Project Name: Ocotillo Brine Reduction Facility Hydrochloric Acid Storage and Weak Acid Containment Mixing Improvements – Change Order No. 3
Project No.: WW2001.403
Rev. 1/16/2024

RE: Project No. WW2001.403 – Ocotillo Brine Reduction Facility HCL Storage and Weak Acid Containment Mixing Improvements – Potential Change Order 009 – DC 005 Pump Hydraulic Solution

Title:	Pump Hydraulic Solution – Lowering Pumps	No.:	005
Request Date:	2/4/2025		
Project:	Ocotillo Brine Reduction Facility HCL Storage and Weak Acid Containment Mixing Improvements		
Contractor:	Garney Construction		
Contract No.:	WW2001.403

DRAWING
X-101A

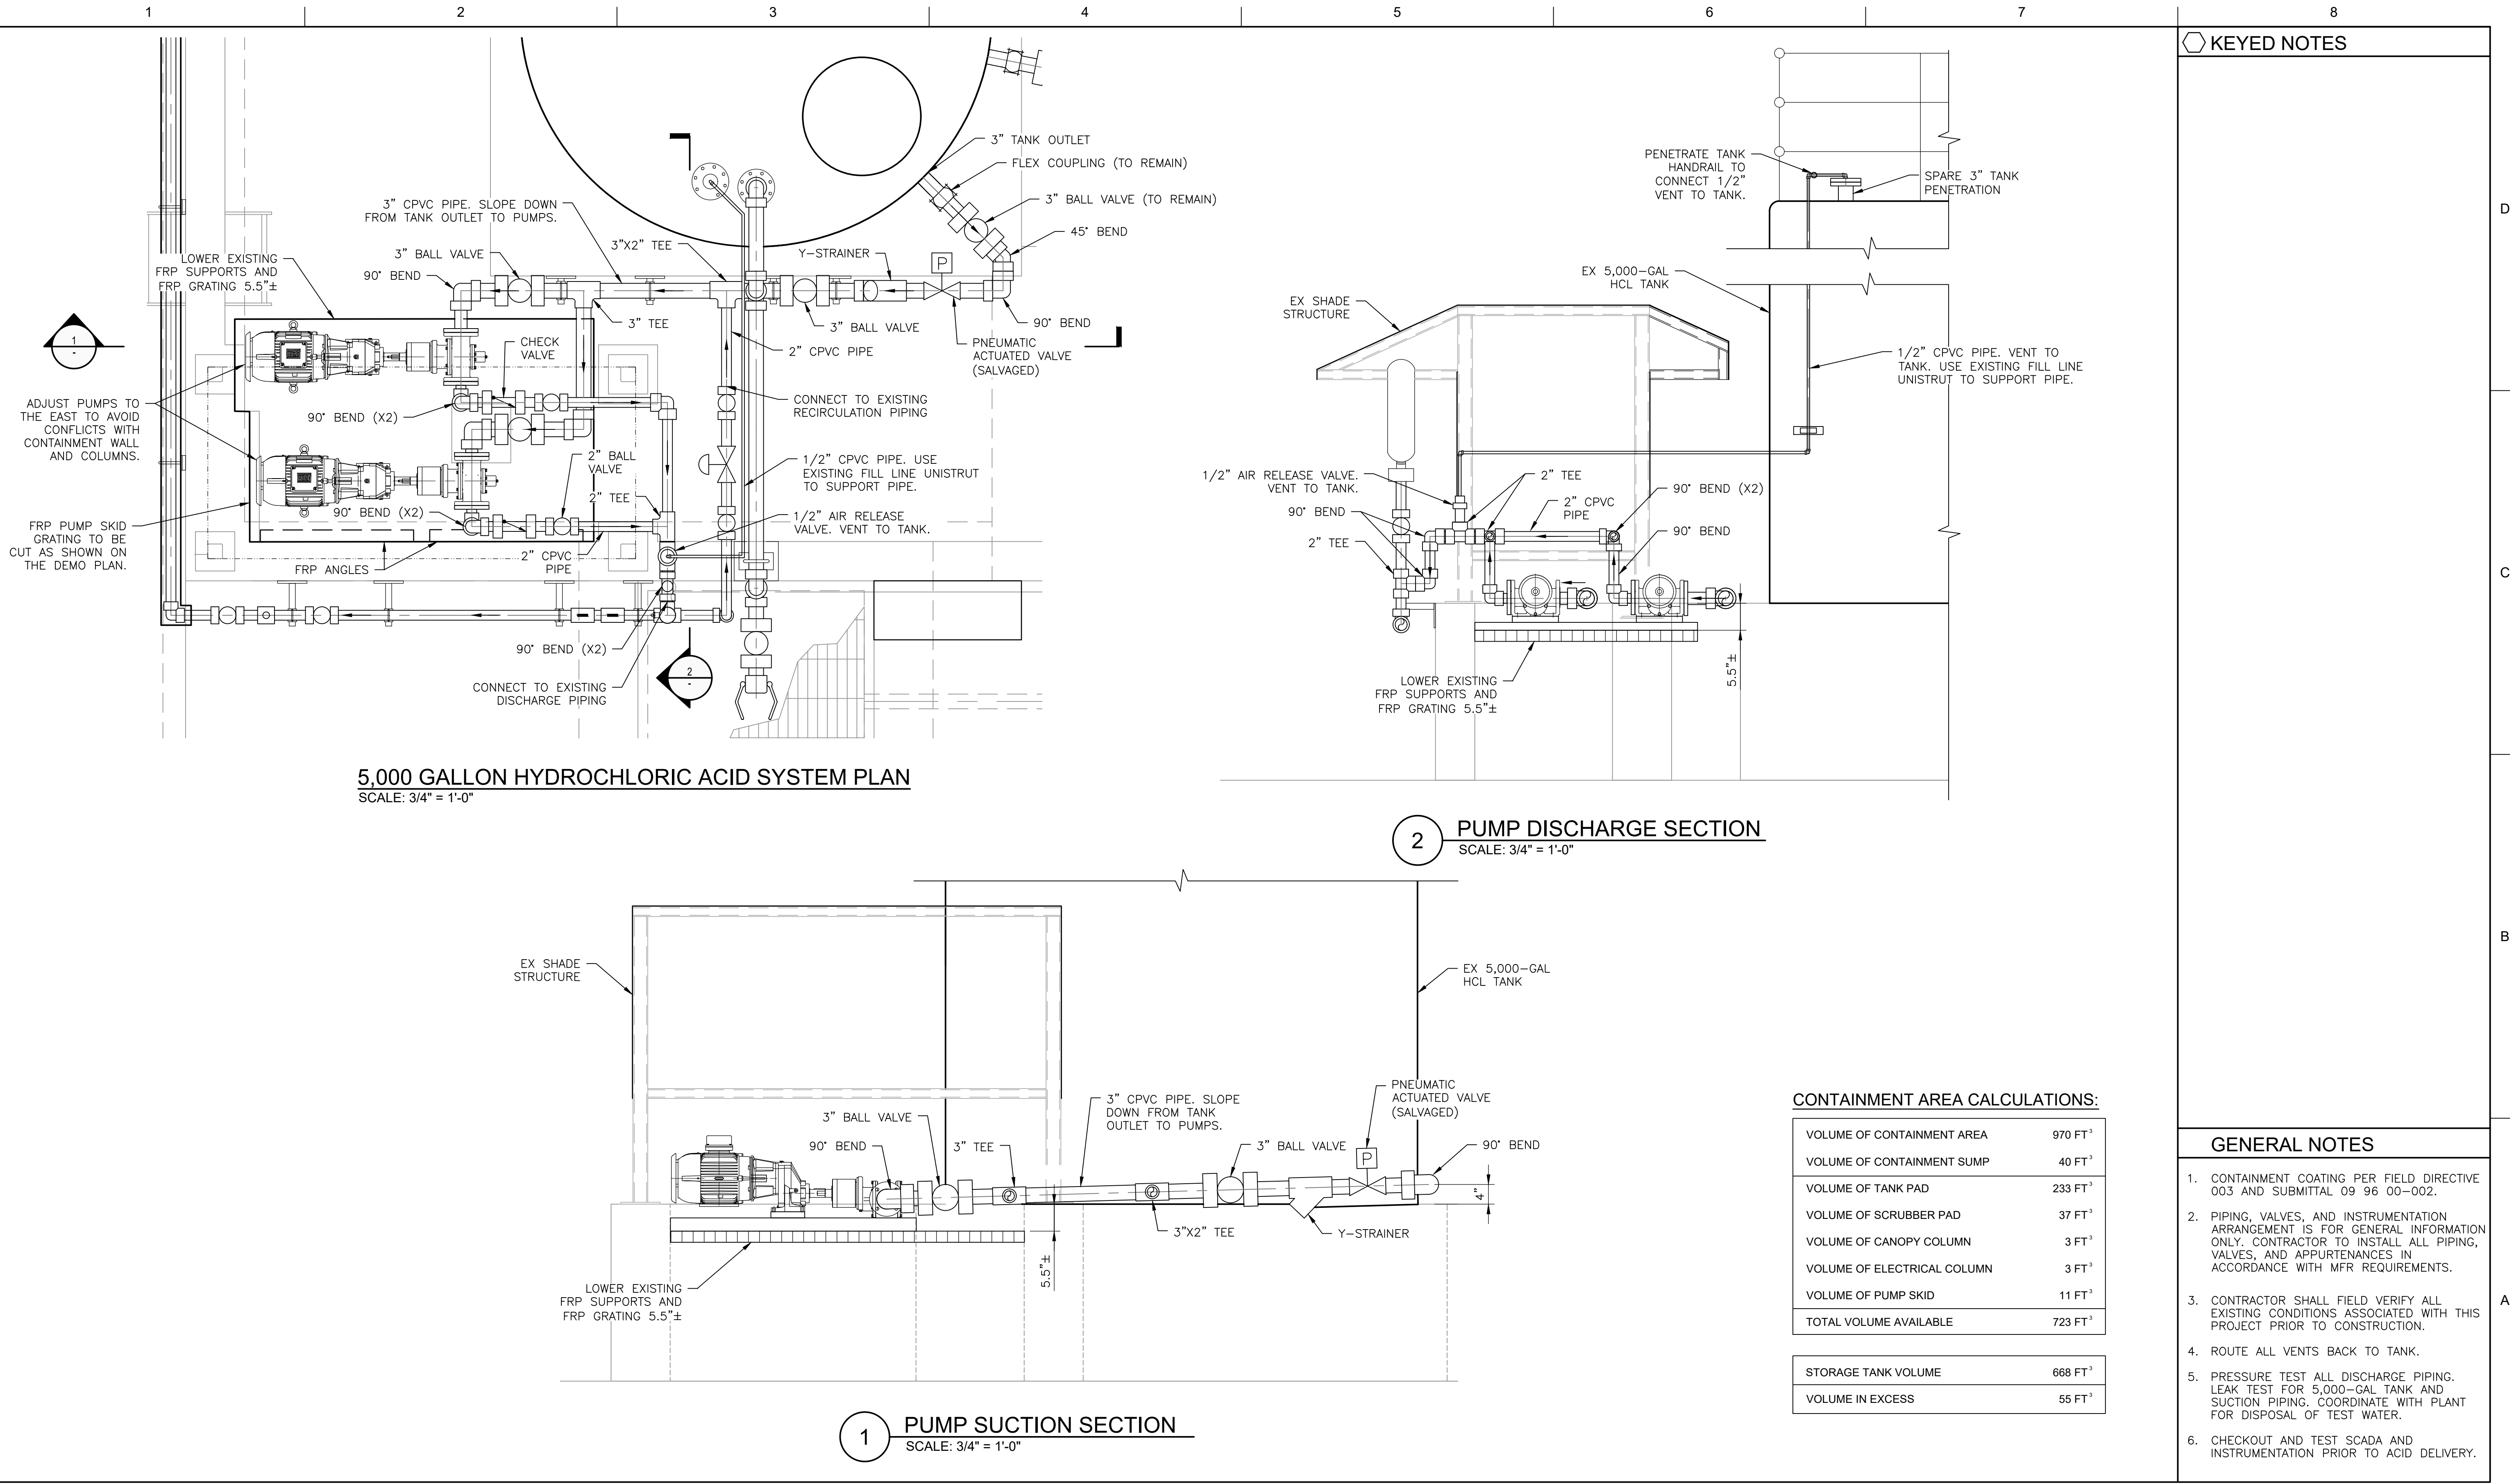
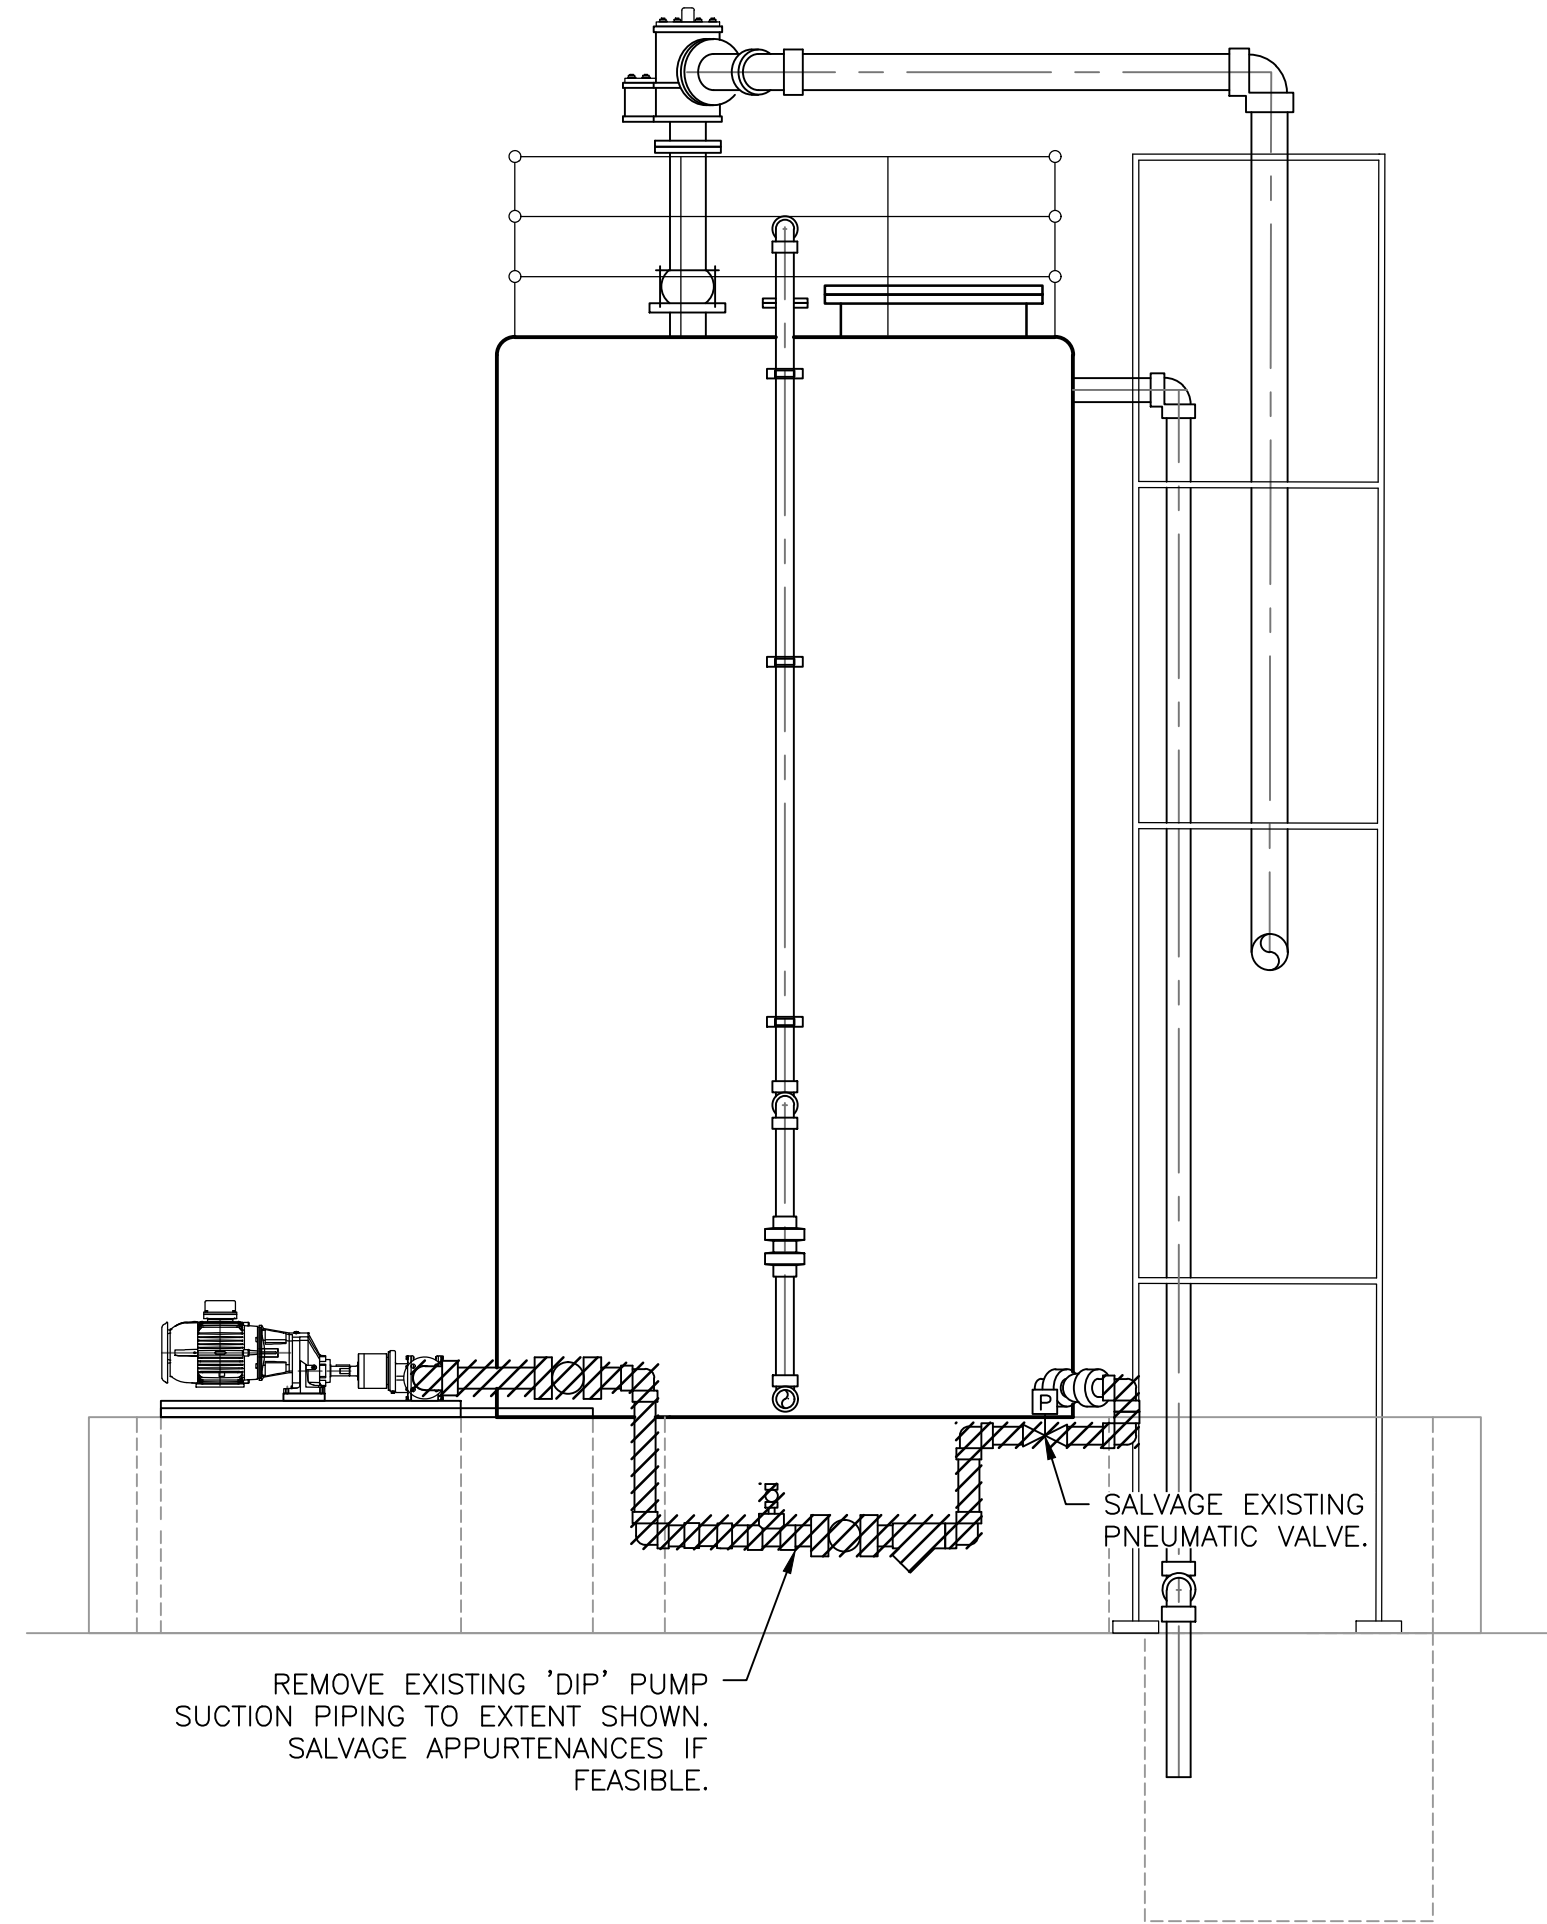
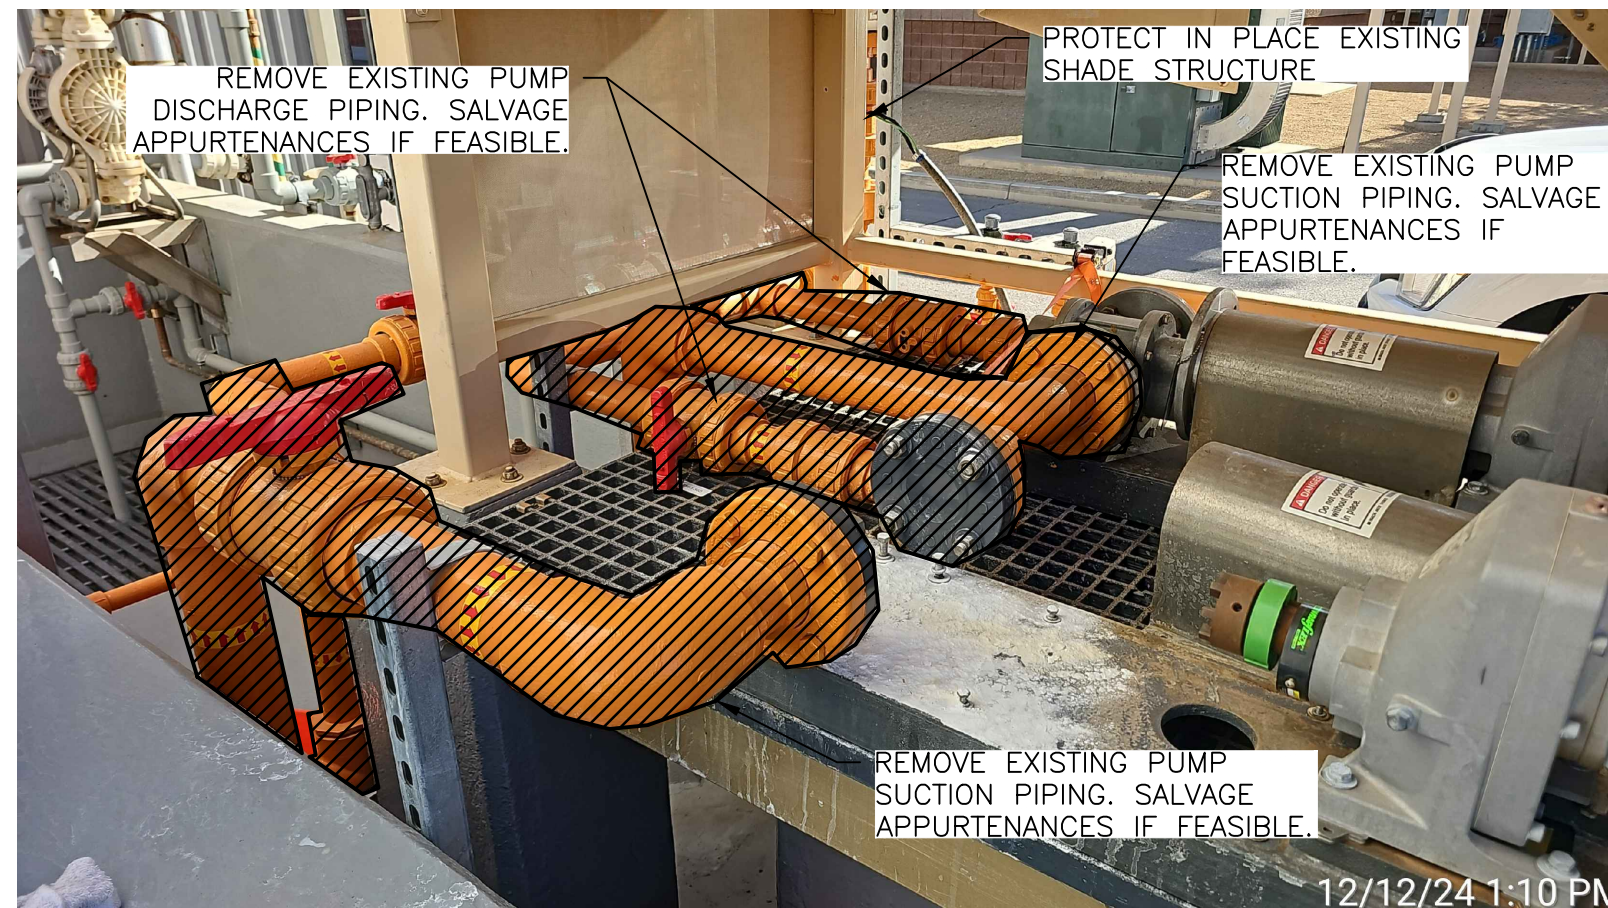
The transfer pumps at the 5,000-gal HCl tank shall be lowered and the pump suction piping modified as shown in the attached drawings. The modifications include the following:

- Pump suction elevation should be equal to or lower than the elevation of the tank outlet penetration.
- Pump suction piping should be reconfigured to slope from the tank outlet down to the pump suction connection.

- Modify/replace pump suction piping. Existing pneumatic shall be salvaged and reused; manual isolation valves shall be reused where possible.
- Cut/trim existing concrete pedestal below pump skid to allow for lowering of pump skid
- Modify pump skid FRP grating and FRP mounting bracket system to be attached to the containment well at a lower elevation
- Reinstall pumps, including alignment and startup by pump manufacturer's representative per specifications
- Modify discharge piping to match new pump elevation.
- Coating of new piping, valves, and fittings; coating of concrete column
